SUNDRY NOTICES AND REPORTS ON WELLS (DO NOT USE THIS FORM FOR PROPOSALS TO DRILL OR DEEPEN OR PLUG BACK TO A DIFFERENT RESERVIOR. USE "APPLICATION FOR PERMIT" (FORM C-101) FOR SUCH PROPOSALS.)		WELL API NO. 30.025.25209

2. Name of Operator Apache Corporation		6. State Oil & Gas Lease No. B-934-13
3. Address of Operator 303 Veterans Airpark Lane, Ste. 3000, Midland, TX 79705		7. Lease Name or Unit Agreement Name State PA

Apache Corporation proposes to P&A the above mentioned well by the attached procedure. A closed loop system will be used for all fluids from this wellbore and disposed of required by OCD Rule 19.15.17.14 NMAC.

**CONDITIONS OF APPROVAL
FOR PLUGGING AND ABANDONMENT
OCD - Southern District**

PROPOSED PROCEDURE

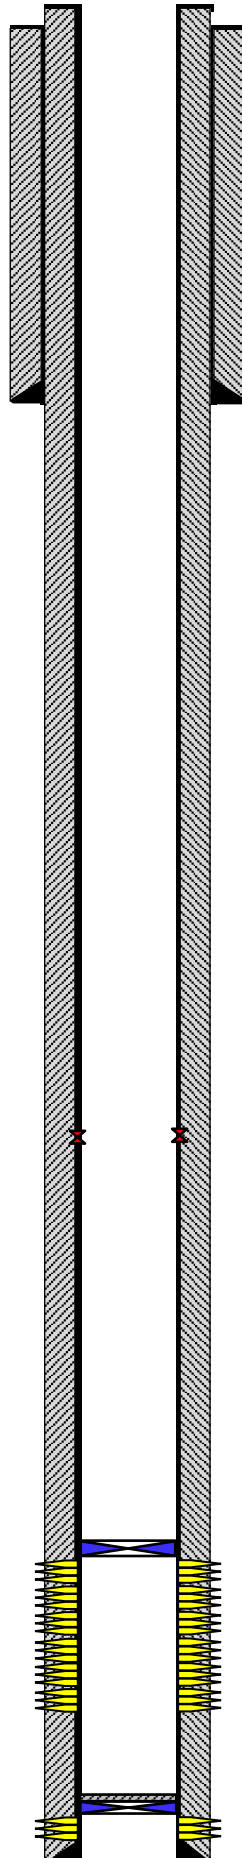
4. PUH & spot 125 sx Class "C" cmt frm 1225' to surf, Fill Up. (Surf Shoe, Top of Salt, Water Board, & Surf Plug)

3. PUH & spot 90 sx Class "C" cmt from 3380'-2519', WOC/TAG (Queen, 7 Rvrs, & Yates)

2. PUH & spot 25 sx Class "C" cmt from 3954'-3754', WOC/TAG (DVT)

1. MIRU P&A rig, RIH w/ Tbg & verify CIBP @ 5425', CIRC w/ MLF & spot 25 sx Class "C" cmt from 5425'-5225'. (Drinkard & Blinebry)
